Niles-Barnard House Renovation

OHM Project No. 0128-18-0020

Project Change Orders

Bulletin # 1

SECTION 07 21 00 - THERMAL INSULATION

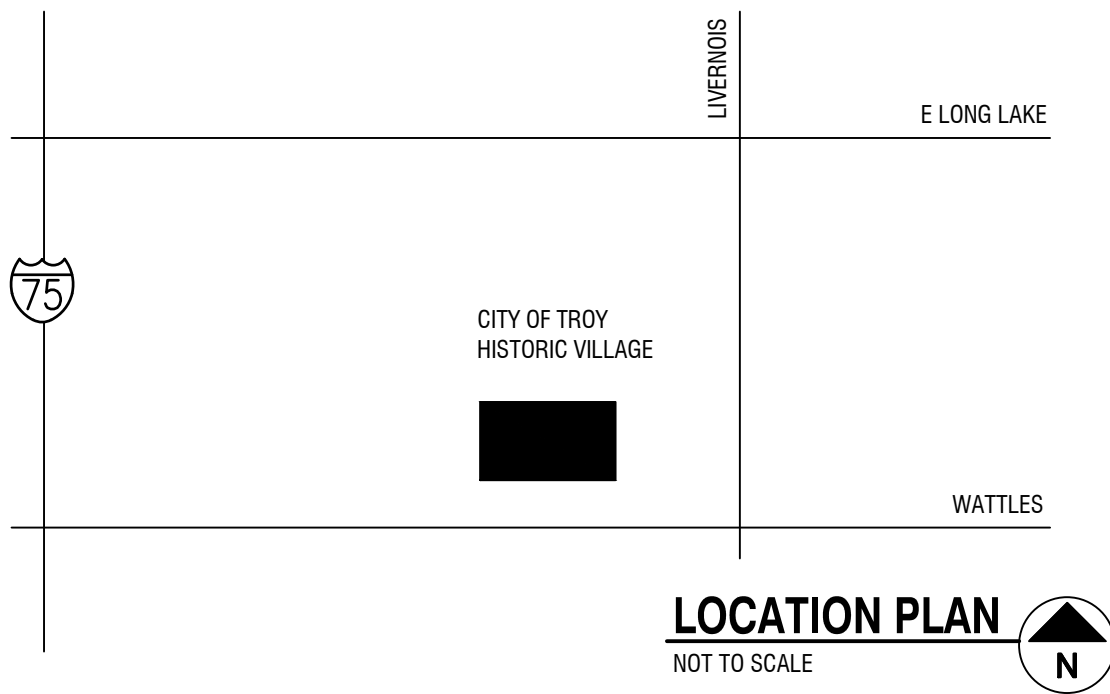
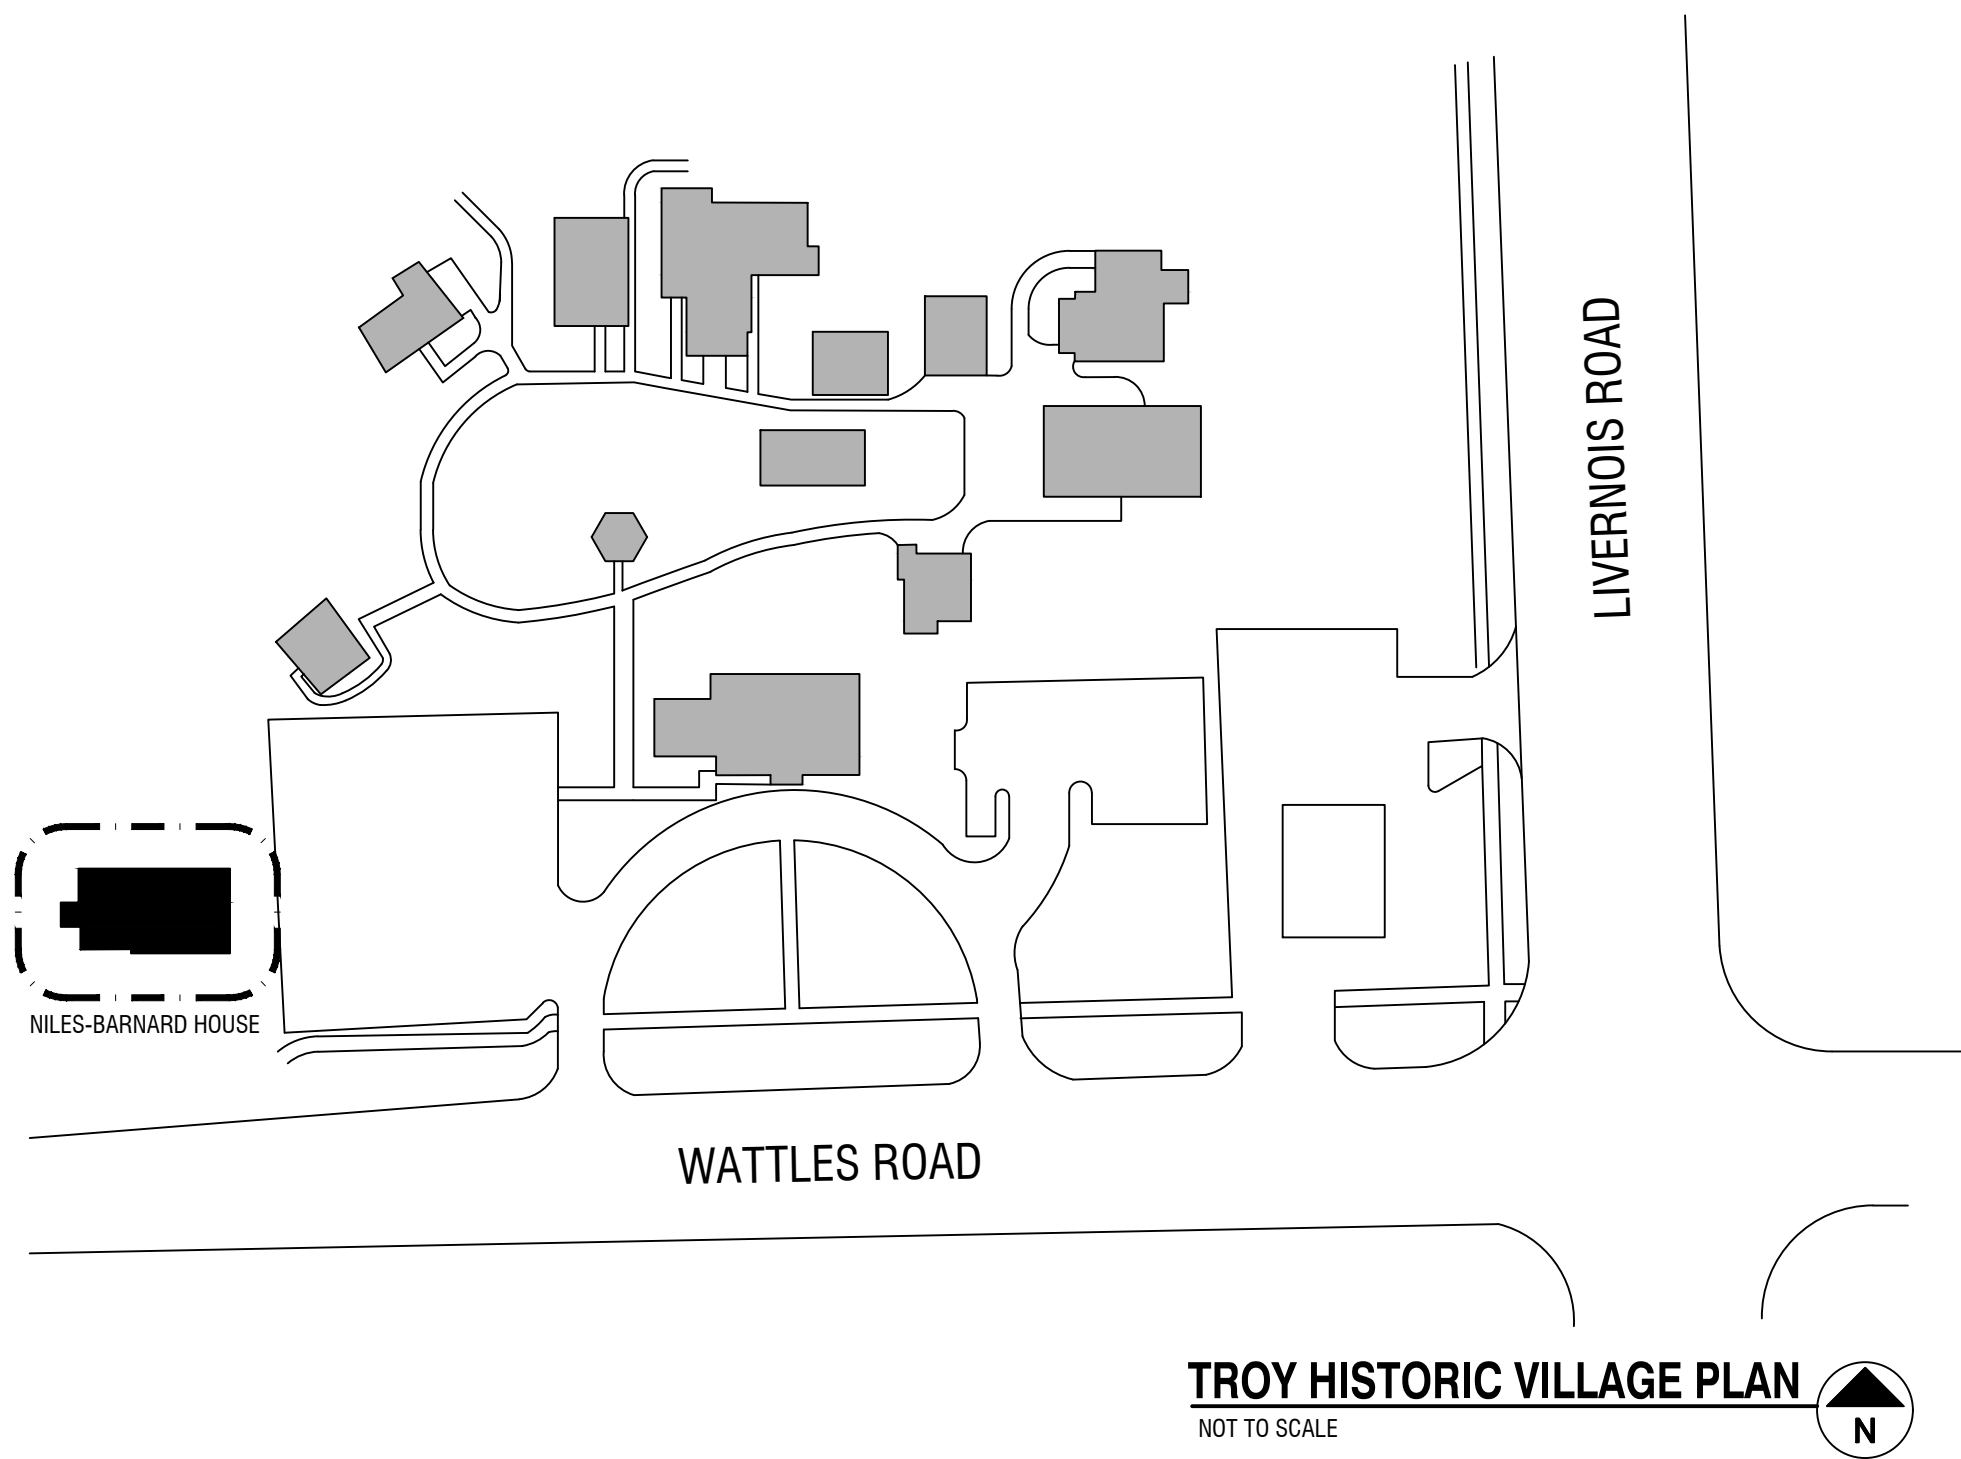
Extruded Polystyrene Foam-Plastic Board insulation in crawlspace replaced with Mineral-Wool Board Insulation.

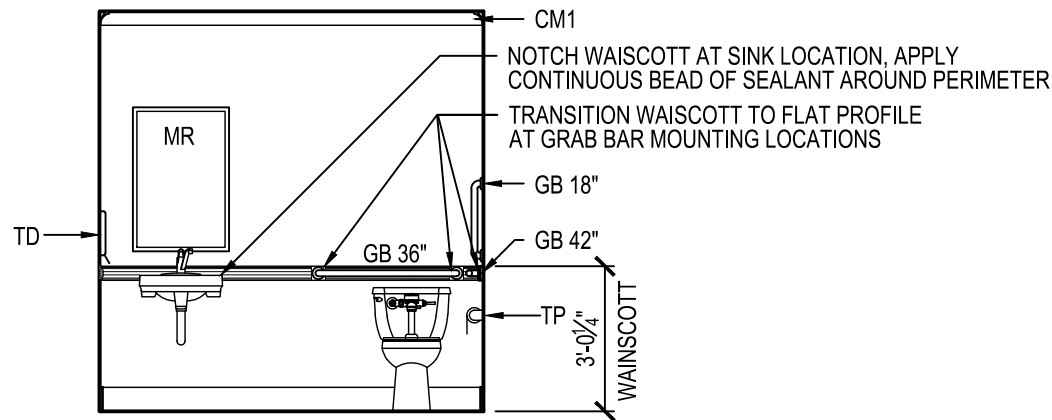
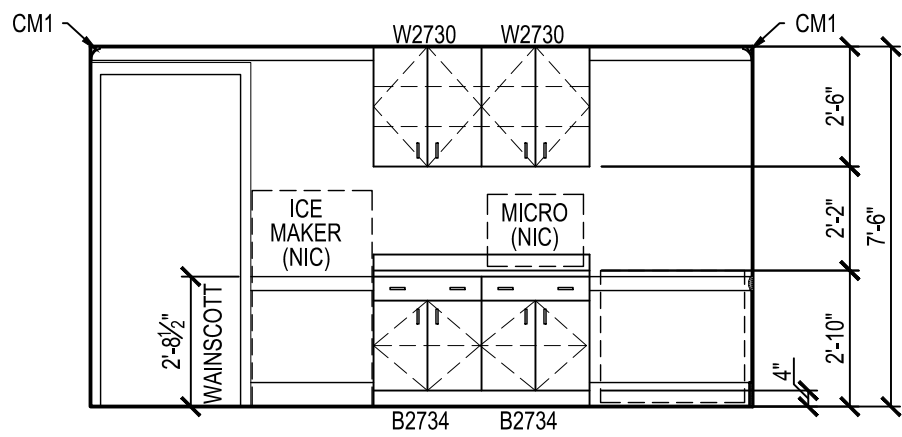
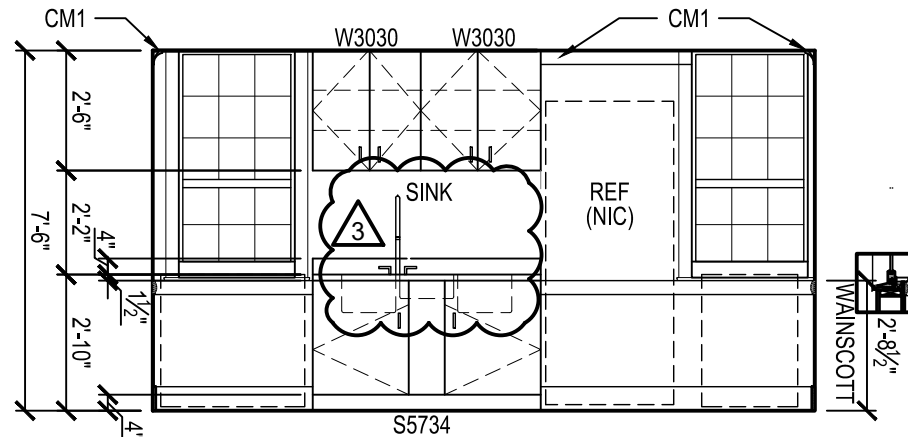
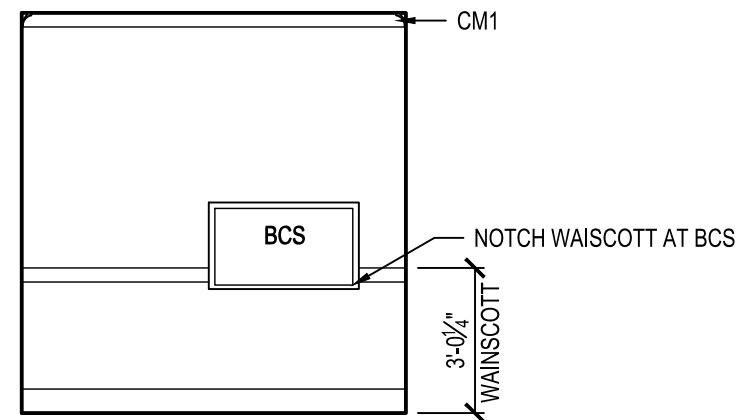
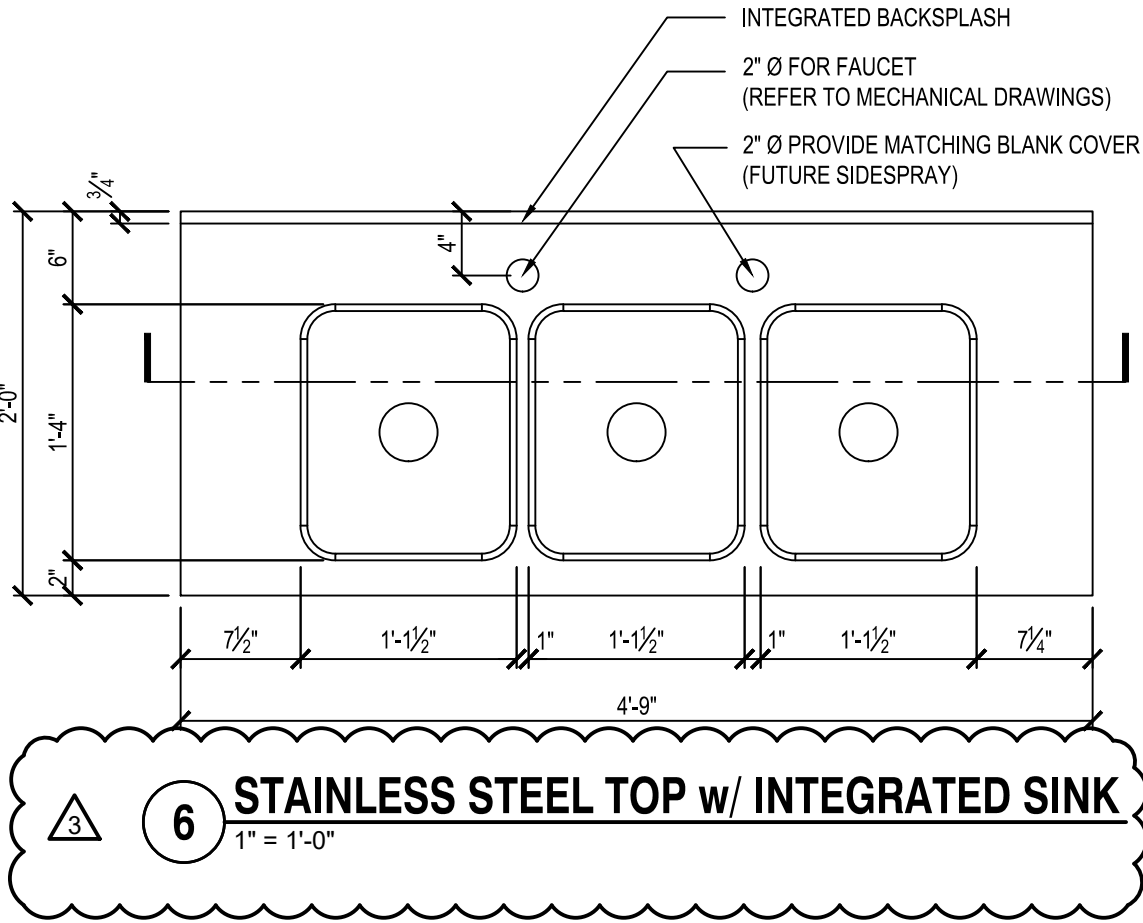
Plastic laminate top and drop in stainless steel sink (SK-1) in Room D 113 replaced with stainless steel countertop with integrated custom three-bowl sink. Faucet finish revised to Vibrant Stainless Steel.

ROOM E AND F NORTH WALL PLYWOOD REINFORCEMENT
1/4" = 1'-0"

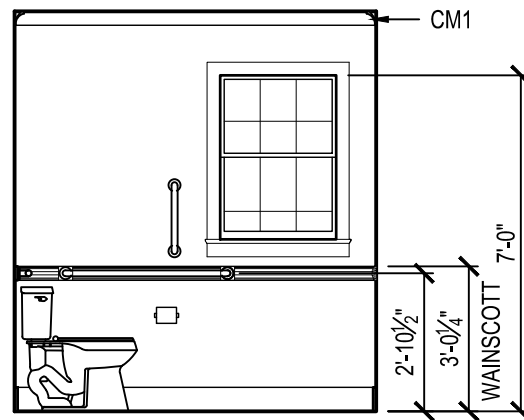
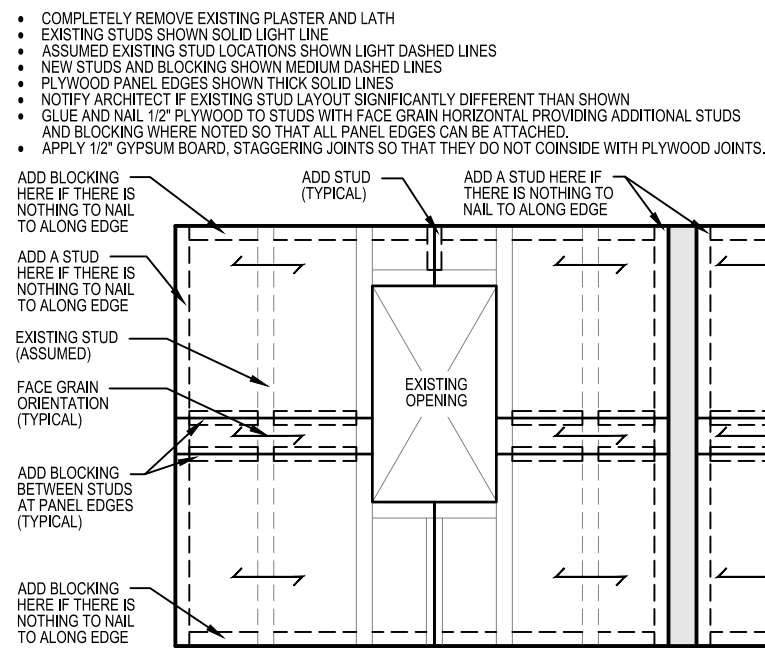
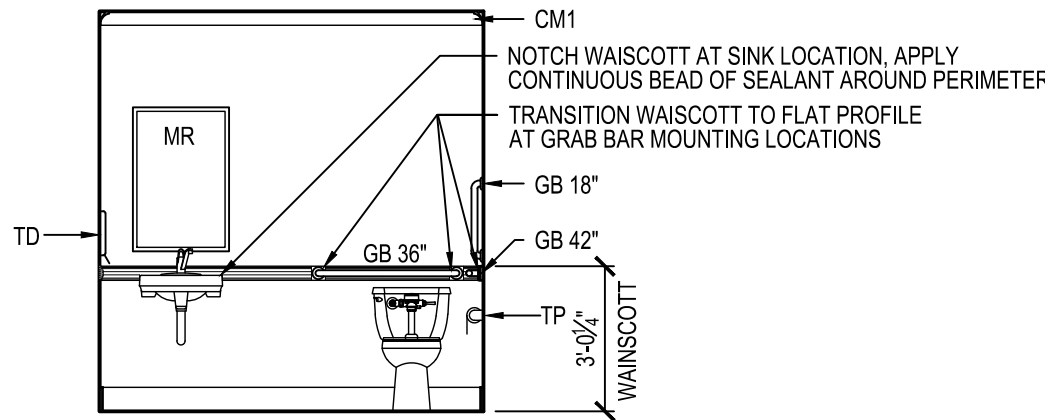
Remove plaster and lath and install plywood and gypsum board as indicated on drawings in Rooms E and F.

SHEET
A-602

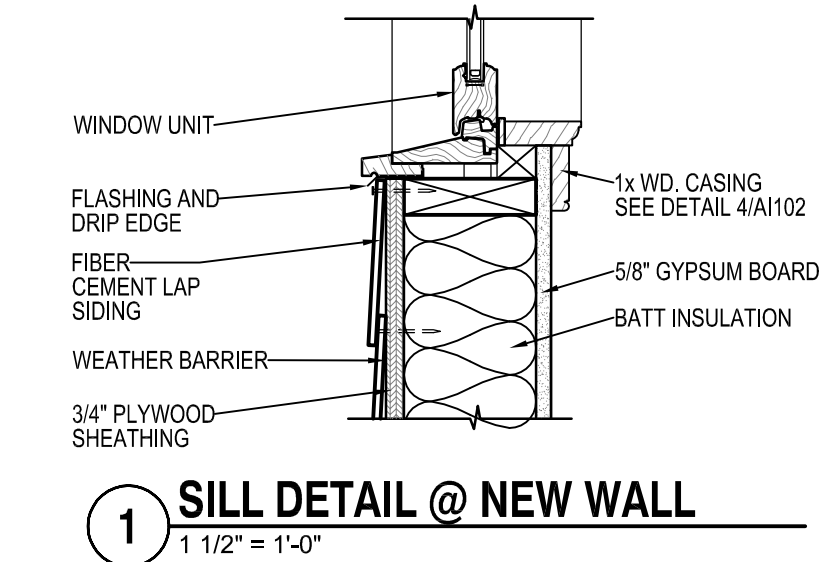
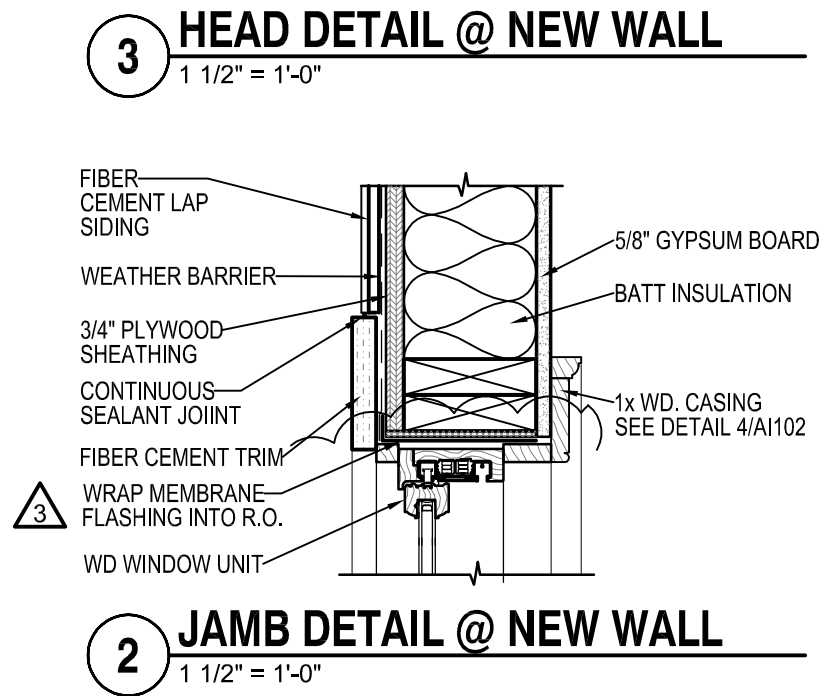
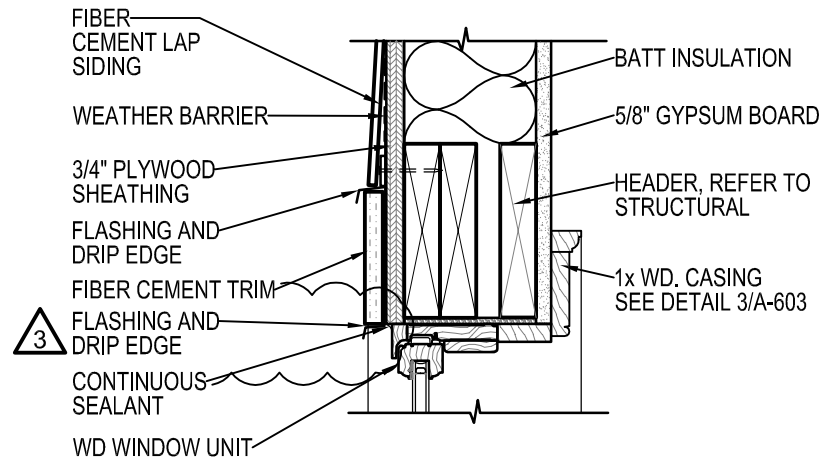
Window muntins revised to 7/8" Bead profile Simulated Divided Lite.

Windows identified in schedule revised to 6 over 6 muntin configuration.
